# UNITED STATES PATENT AND TRADEMARK OFFICE

APPLICATION NO.	FILING DATE	FIRST NAMED INVENTOR	ATTORNEY DOCKET NO.	CONFIRMATION NO.
10/014,227	12/11/2001	Benoit R. Veillette	US010594	3093

## Office Action Summary

FIG. 1

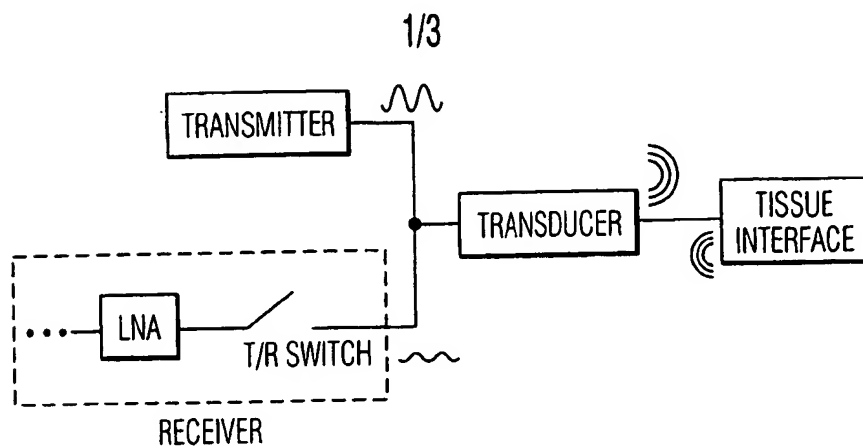
1. Figures 1-5 should be designated by a legend such as --Prior Art-- because only that which is old is illustrated. See MPEP § 608.02(g). Corrected drawings in compliance with 37 CFR 1.121(d) are required in reply to the Office action to avoid abandonment of the application. The replacement sheet(s) should be labeled "Replacement Sheet" in the page header (as per 37 CFR 1.84(c)) so as not to obstruct any portion of the drawing figures. If the changes are not accepted by the examiner, the applicant will be notified and informed of any required corrective action in the next Office action. The objection to the drawings will not be held in abeyance.

Regarding claim 1. Applicants openly admit that prior art teaches a receiver circuit (see RECEIVER in figure 1), comprising:

a switch for blocking high voltages and for converting voltage signals to current signals (see T/R switch in figure 1), said switch comprising first and second signal terminals (see conventional T/R switch depicted in figure 4B wherein first terminal is labeled as 405 and second terminal labeled as 410) and a control terminal (see control terminal labeled as 400 figure 4B) said switching exhibiting an ON resistance when closed, said ON resistance controlled by an electric value at said control terminal;

Regarding claim 2. Applicants openly admit that prior art already teaches T/R switch (see T/R SWITCH in figure 1) used to couple transducer (see TRANSDUCER figure 1) and low-noise amplifier (see LNA coupled to other side of T/R switch in figure 1).

Regarding claim 14. Applicants openly admit that prior art already teaches T/R switch (see T/R SWITCH in figure 1) used to couple transducer (see TRANSDUCER figure 1) and low-noise amplifier (see LNA coupled to other side of T/R switch in figure 1).

FIG. 4A

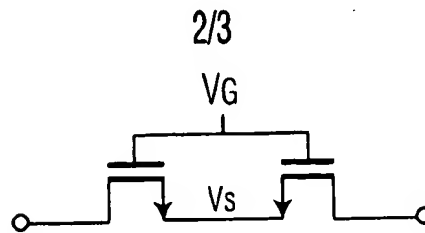
a control circuit coupled to said switch for controlling said ON resistance of said switch in closed position (see figure 4A and Applicants admitted prior art at top of page 4 in Applicants specification wherein control circuit shown used to control resistance of T/R switch shown in figure 4B).

a T/R switch for blocking high voltages and for converting voltage signals to current signals (see T/R switch in figure 1), said T/R switch comprising first and second signal terminals (see conventional T/R switch depicted in figure 4B wherein first terminal is labeled as 405 and second terminal labeled as 410;

Regarding claim 9. Applicants already admit that prior art teaches control terminal (see control terminal labeled as 400 figure 4B) said switching exhibiting an ON

resistance when closed, said ON resistance controlled by an electric value at said control terminal, the receiver circuit further comprising a control circuit coupled to said switch for controlling said ON resistance of said switch in closed position (see figure 4A and Applicants admitted prior art at top of page 4 in Applicants specification wherein control circuit shown used to control resistance of T/R switch shown in figure 4B).

FIG. 5

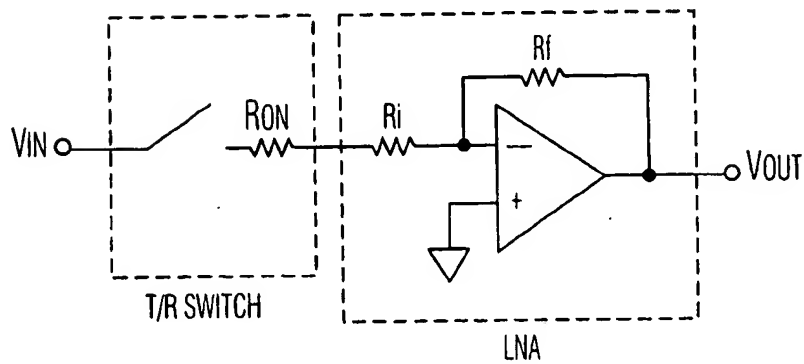
Regarding claim 4. Applicants admit that receiver circuit of claim 2 wherein low-noise amplifier circuit requires an input resistance (see  $R_i$  for LNA circuit shown in prior art figure 5) and a feedback resistance (see  $R_F$  for LNA circuit shown in prior art figure 5), and further wherein on resistance of switch is input resistance of said low-noise amplifier circuit (see  $R_O$  of switch inputted to resistance of LNA figure 5).

a low-noise amplifier (see LNA of admitted prior art figure 5) for amplifying low-voltage pulses while minimizing electronic noise, said amplifier circuit requiring an input resistance (see  $R_i$  figure 5) and feedback resistance (see  $R_f$  figure 5), wherein said input resistance is said ON resistance of said T/R switch (see figure 5 wherein  $R_{on}$  of switch must match input impedance of LNA).

Regarding claim 16. Applicants admit that receiver circuit of claim 2 wherein low-noise amplifier circuit requires an input resistance (see  $R_i$  for LNA circuit shown in prior art figure 5) and a feedback resistance (see  $R_F$  for LNA circuit shown in prior art figure 5), and further wherein on resistance of switch is input resistance of said low-noise amplifier circuit (see  $R_O$  of switch inputted to resistance of LNA figure 5).

FIG. 7

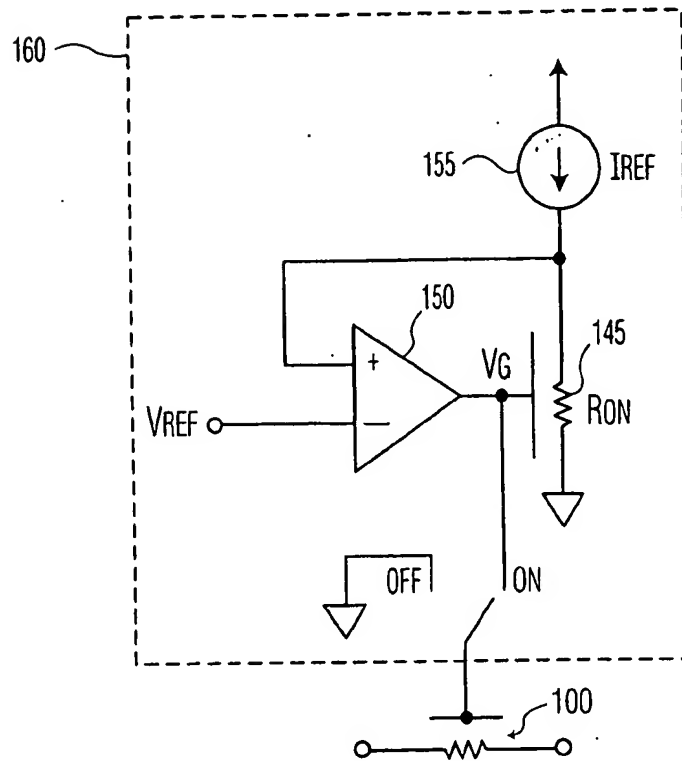
Regarding claims 5-7, 10-12 and 17-19. Applicants admit that prior art (see figures 1-5) fail to show a servo-loop depicted in figure 7.
